Two Rivers Community School, Mareeba

SARA reference: 2311-38006 SRA
Council reference: MCU/23/0012
Applicant reference: F22/31

SARA referral agency response

Description:	Development permit	Material change of use - Educational Establishment
SARA role:	Referral agency	
SARA trigger:	Schedule 10, Part 3, Division 4, Table 3, Item 1 (10.3.4.3.1) of the Planning Regulation 2017 - Clearing native vegetation

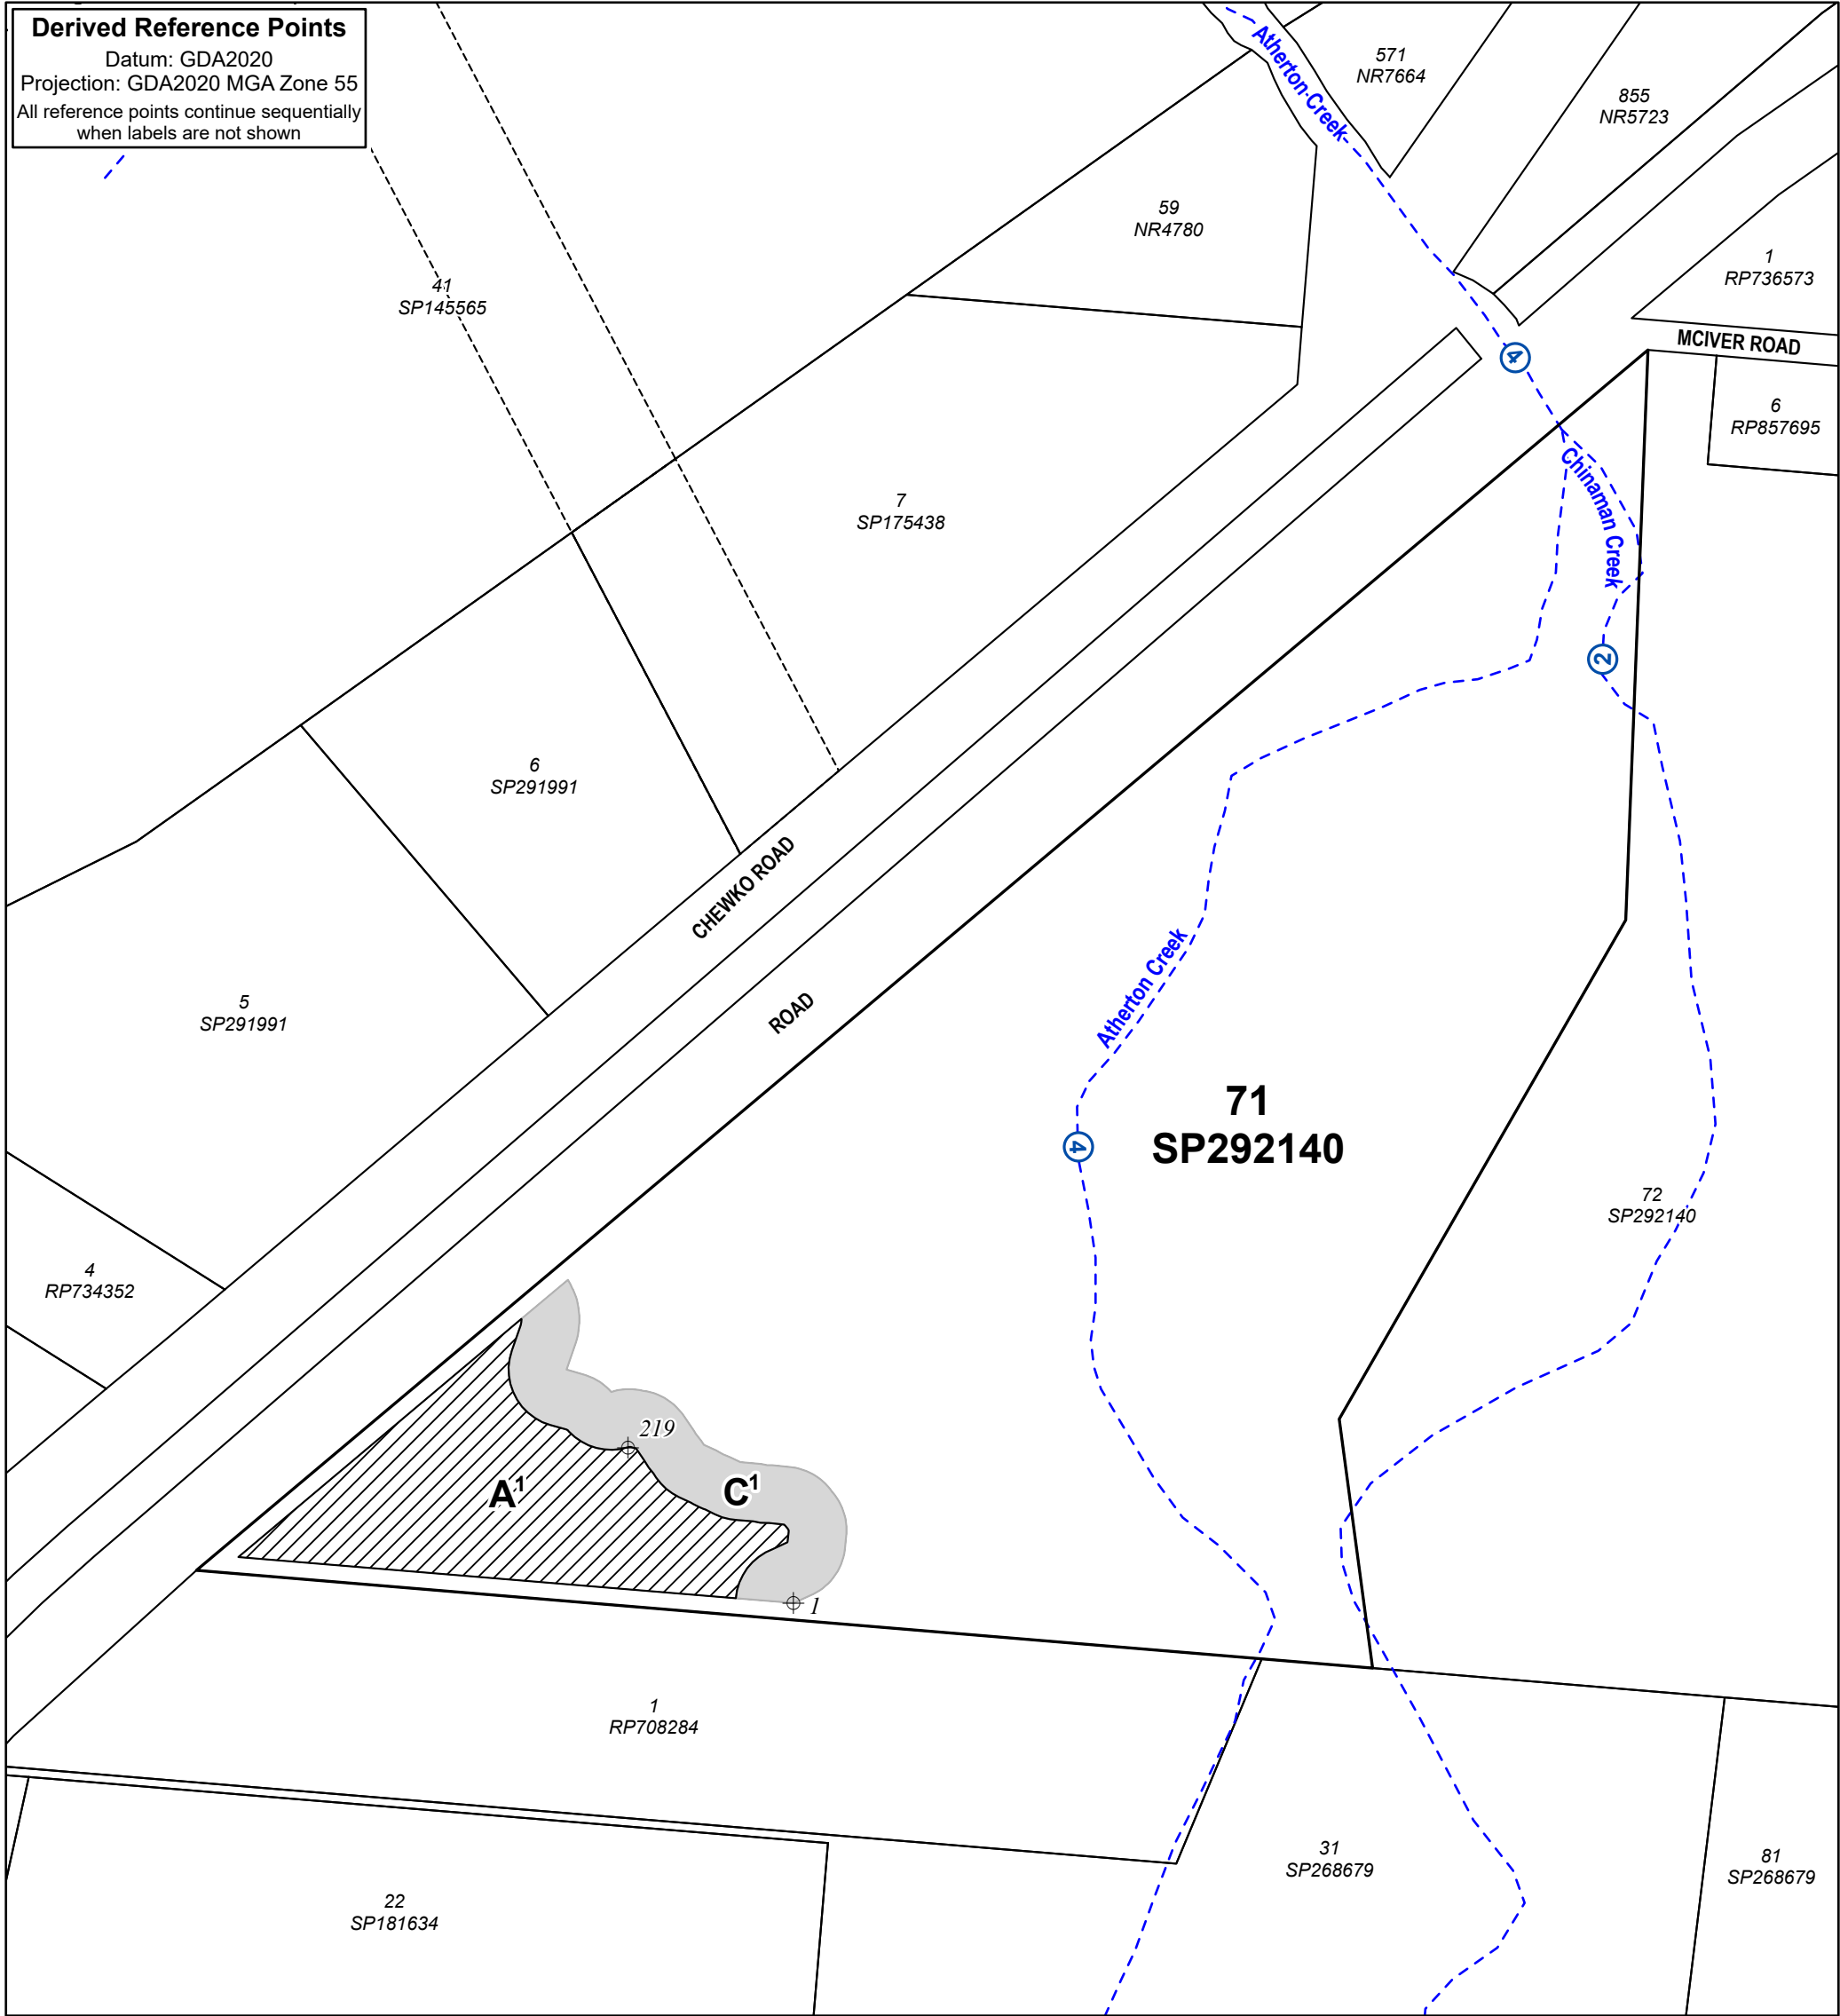
1.	Clearing of vegetation must: (a) only occur within Area A(A1) and Area C(C1) as shown on the attached: (i) Vegetation Management Plan, prepared by Queensland Government, reference VMP 2311-38006 SRA, Sheet 1 of 1, version 1; and (ii) Attachment to Vegetation Management Plan VMP 2311-38006 SRA Derived Reference Points for GPS; (b) not exceed 3.314 hectares.	At all times

2.	Built infrastructure, other than for roads, tracks, fences and underground services, must not be established, constructed or located within Area C(C1) as shown on the attached: (i) Vegetation Management Plan, prepared by Queensland Government, reference VMP 2311-38006 SRA, Sheet 1 of 1, version 1; and (ii) Attachment to Vegetation Management Plan VMP 2311-38006 SRA Derived Reference Points for GPS.	At all times

Masterplan 2041 School B&W

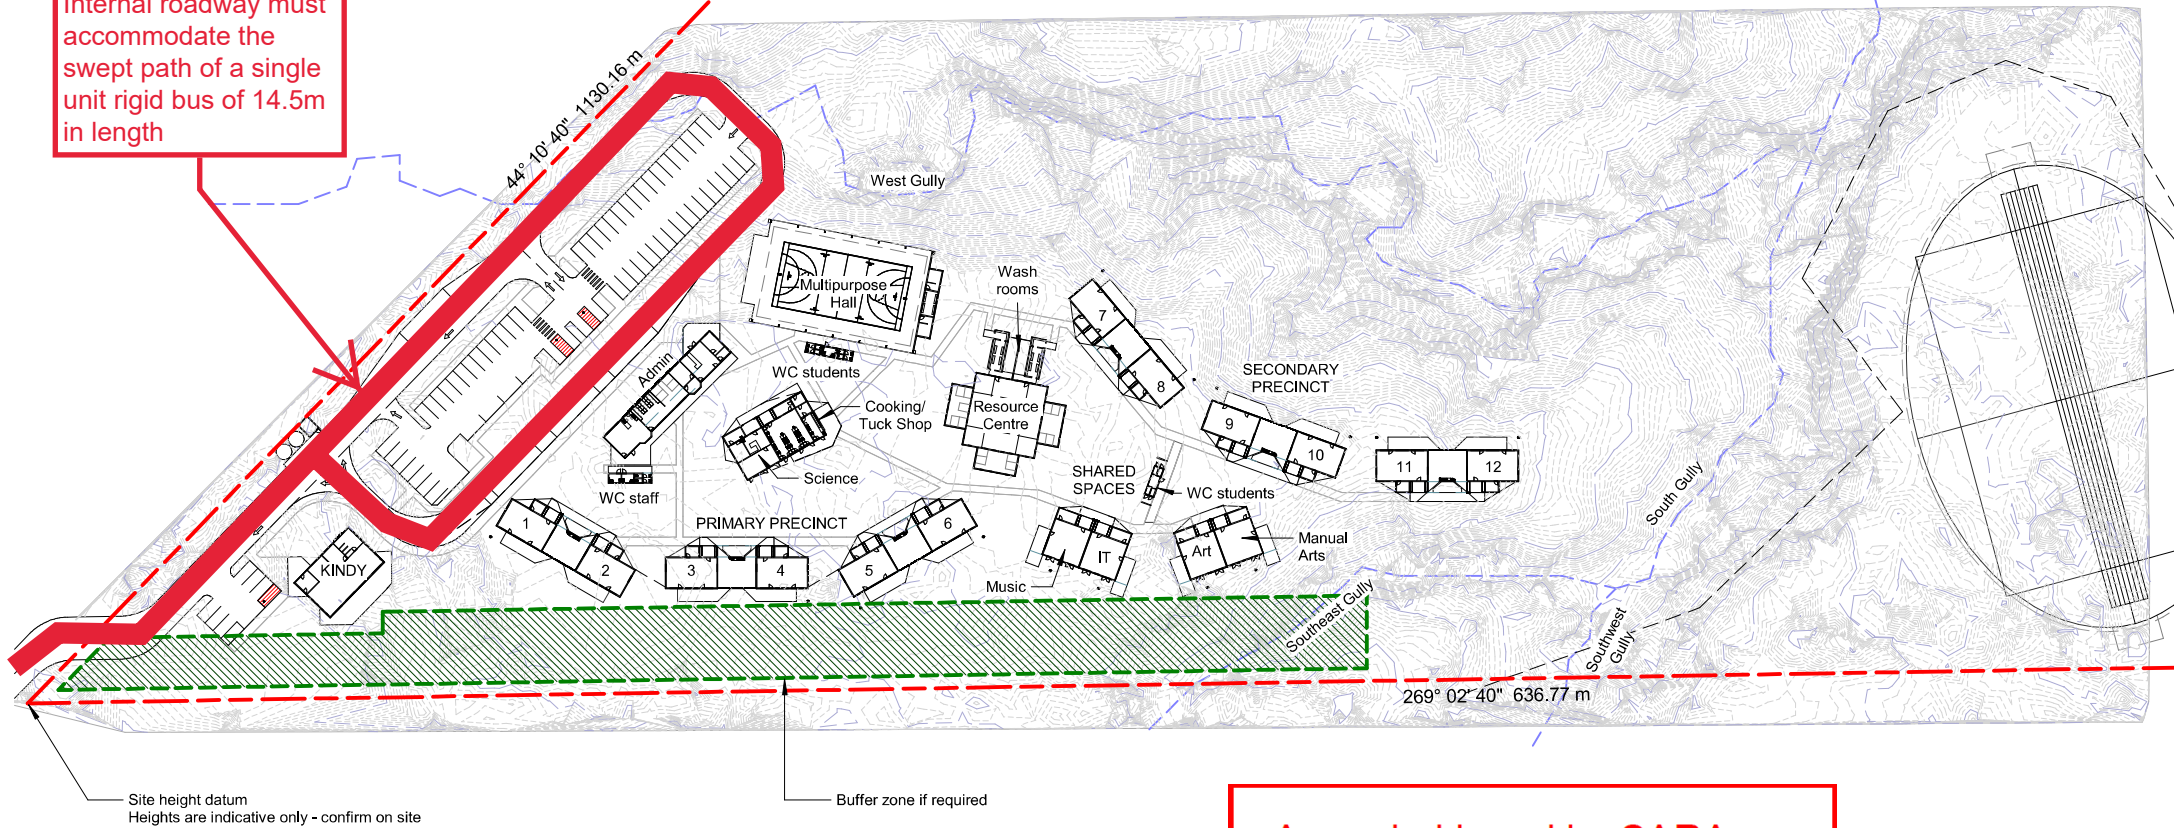
Internal roadway must accommodate the swept path of a single unit rigid bus of 14.5m in length

Amended in red by SARA on
30 May 2024

9.	<p>The property access and internal roadway shown on Masterplan 2041 School B&W, prepared by Life Design, dated 10/10/2023, drawing number 162/A041c and issue 6 (as amended in red) must be designed and constructed to be in accordance with the following to accommodate a single unit rigid bus of 14.5m in length:</p> <ul style="list-style-type: none"> (c) accommodate the swept path of a single unit rigid bus of 14.5m in length in accordance with Austroads Design Vehicles and Turning Path Templates; (d) include wayfinding signage to identify the separate vehicular routes to passenger loading zones, parking areas, exits and the like in accordance with the Queensland Manual of Uniform Traffic Control Devices, Part 2: Traffic Control Devices for General Use; and (e) provide priority movement to the 'bus route' over private vehicle routes by installing give way pavement marking and signage in accordance with sections 2.5 and 5.5.2 of Queensland Manual of Uniform Traffic Control Devices, Part 2: Traffic Control Devices for General Use. 	Prior to the commencement of use for the relevant stage

Stage 1 Plan - Parking and Drop-off

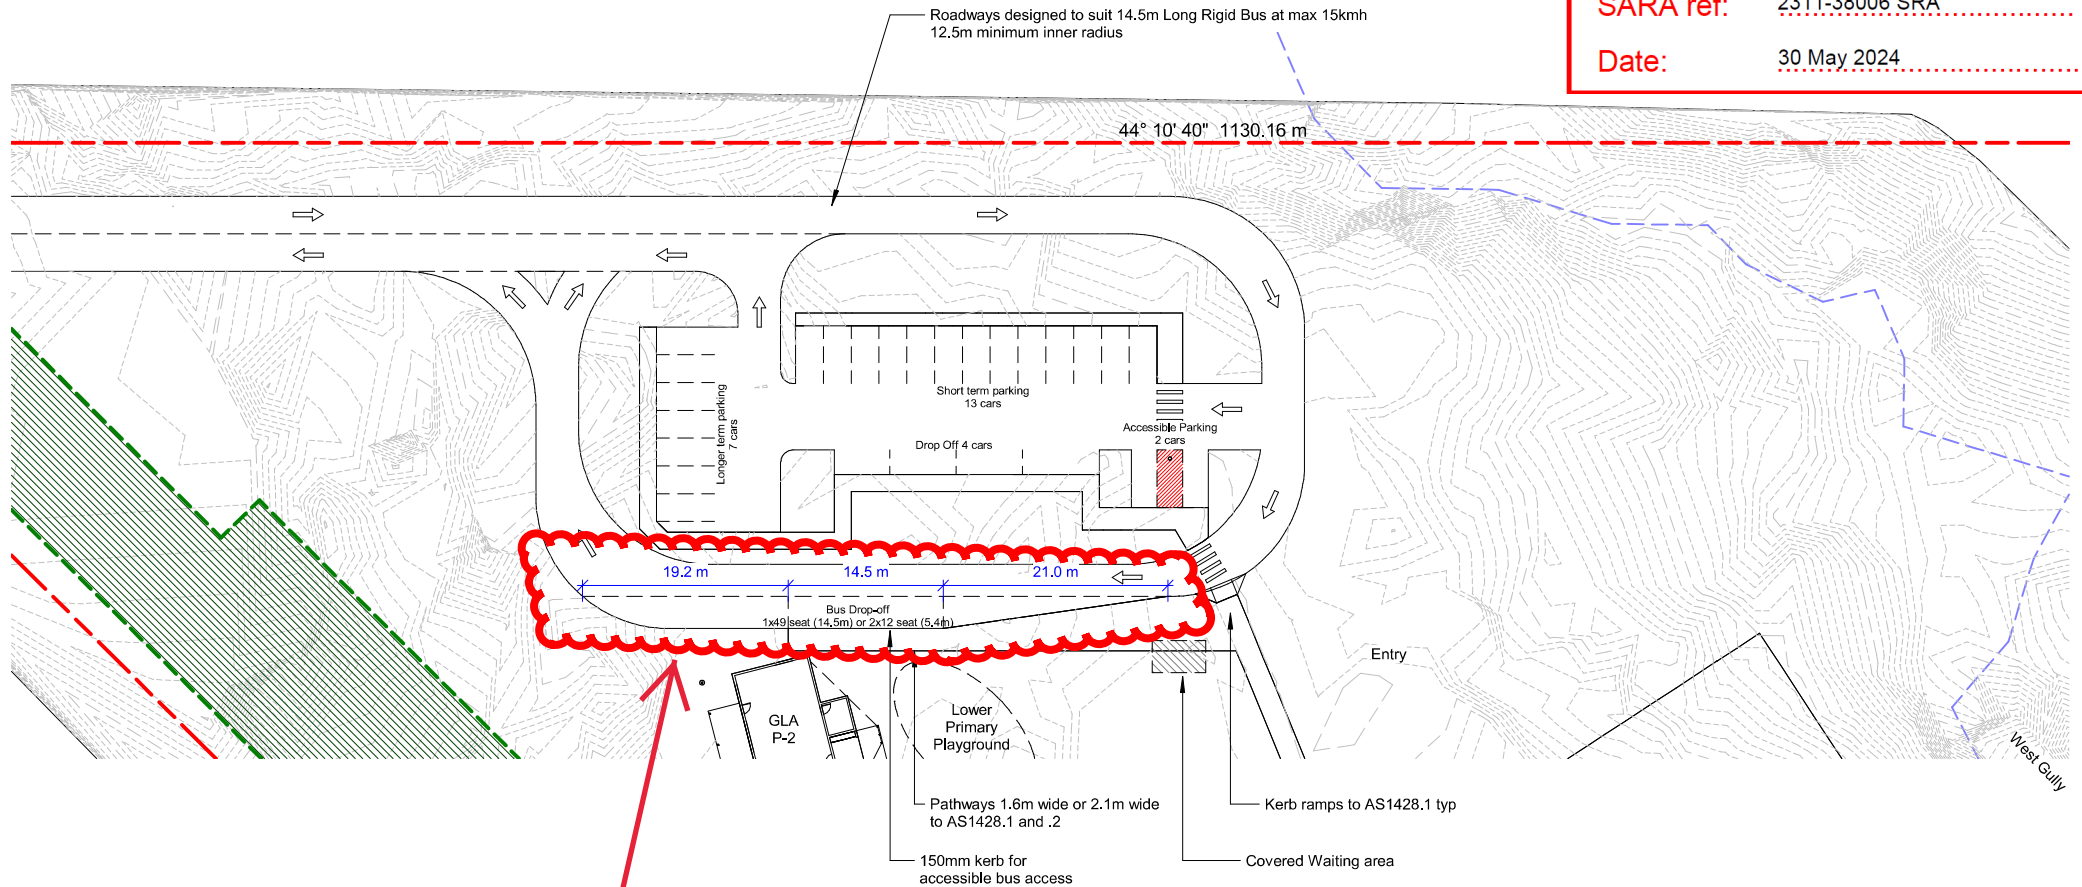
Provide bus setdown
facility in accordance
with the conditions of
the SARA Referral
Agency Response

Amended in red by SARA on
30 May 2024

Public passenger transport		
7.	<p>(a) Provide a school bus setdown facility at the location shown on the Stage 1 Plan – Parking and Drop-off, prepared by Life Design, dated 24/07/2023, drawing number 162/A112 and issue 3 (as amended in red).</p> <p>(b) The school bus setdown facility must be in accordance with the <i>Disability Standards for Accessible Public Transport 2002</i> made under subsection 31(1) of the <i>Disability Discrimination Act 1992</i> and include the following components:</p> <p>(i) one (1) continuous bus zone with capacity to accommodate the setdown of 1 x single unit rigid bus of 14.5m in length in accordance with Section 5.6.3.1 and Table 5-7 of Chapter 5 of the <i>Public Transport Infrastructure Manual 2015</i>.</p> <p>(ii) bus zone line marking and bus zone signage at either end of the bus zone in accordance with AS1742.11 – <i>Manual of uniform traffic control devices, Part 11: Parking controls</i>.</p> <p>(iii) a waiting area with shelter, seats and a bin in accordance with P2.1 – P2.4, S2, Outcome 1, Table 2 of <i>Planning for Safe Transport Infrastructure at Schools</i>.</p>	<p>(a) and (b) Prior to the commencement of use for Stage 1</p>

Pedestrian and cyclist access		
10.	<p>(a) Provide the external and internal pedestrian pathway network, generally in accordance with the Stage 1 Plan – Parking and Drop-off, prepared by Life Design, dated 24/07/2023, drawing number 162/A112 and issue 3 (as amended by SARA in red).</p> <p>(b) The active transport network in part (a) of this condition must be in accordance with Table 1: Active Transport and Schedule 1 of <i>Planning for Safe Transport Infrastructure at Schools</i>.</p>	(a) and (b) Prior to the commencement of use for the relevant stage

1 : 500 @ A3
Final Plan - Parking and Drop-off

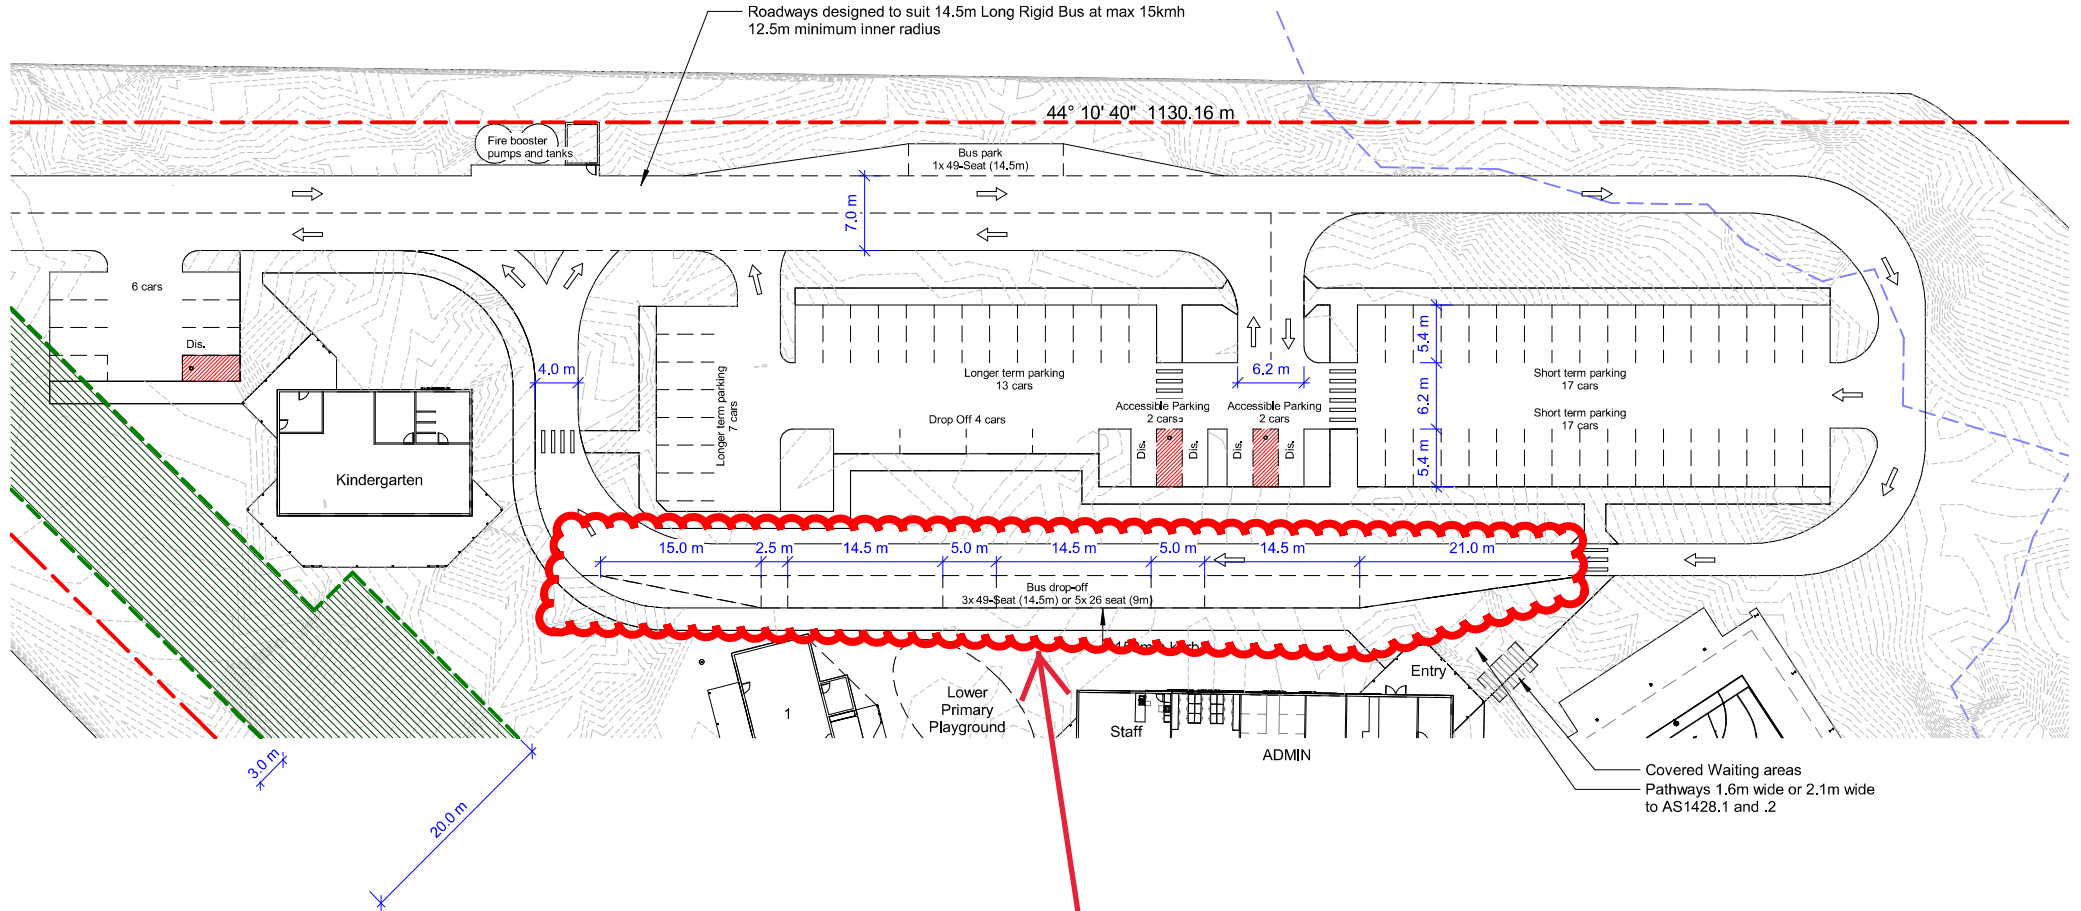
Provide bus setdown
facility in accordance
with the conditions of
the SARA Referral
Agency Response

Amended in red by SARA on
30 May 2024

8.	<p>(a) Provide a school bus setdown facility at the location shown on the Final Plan – Parking and Drop-off, prepared by Life Design, dated 24/07/2023, drawing number 162/A162 and issue 3 (as amended in red).</p> <p>(b) The school bus setdown facility must be in accordance with the <i>Disability Standards for Accessible Public Transport 2002</i> made under subsection 31(1) of the <i>Disability Discrimination Act 1992</i> and include the following components:</p> <ul style="list-style-type: none"> (i) one (1) continuous bus zone with capacity to accommodate the concurrent setdown of 3 x single unit rigid buses of 14.5m in length with independent operation in-between in accordance with Section 5.6.3.1 and Table 5-7 of Chapter 5 of the <i>Public Transport Infrastructure Manual 2015</i>. (ii) bus zone line marking and bus zone signage at either end of the bus zone in accordance with AS1742.11 – Manual of uniform traffic control devices, Part 11: Parking controls. (iii) a waiting area with shelter, seats and a bin in accordance with P2.1 – P2.4, S2, Outcome 1, Table 2 of <i>Planning for Safe Transport Infrastructure at Schools</i>. 	(a) and (b) Prior to the commencement of use for Stage 5
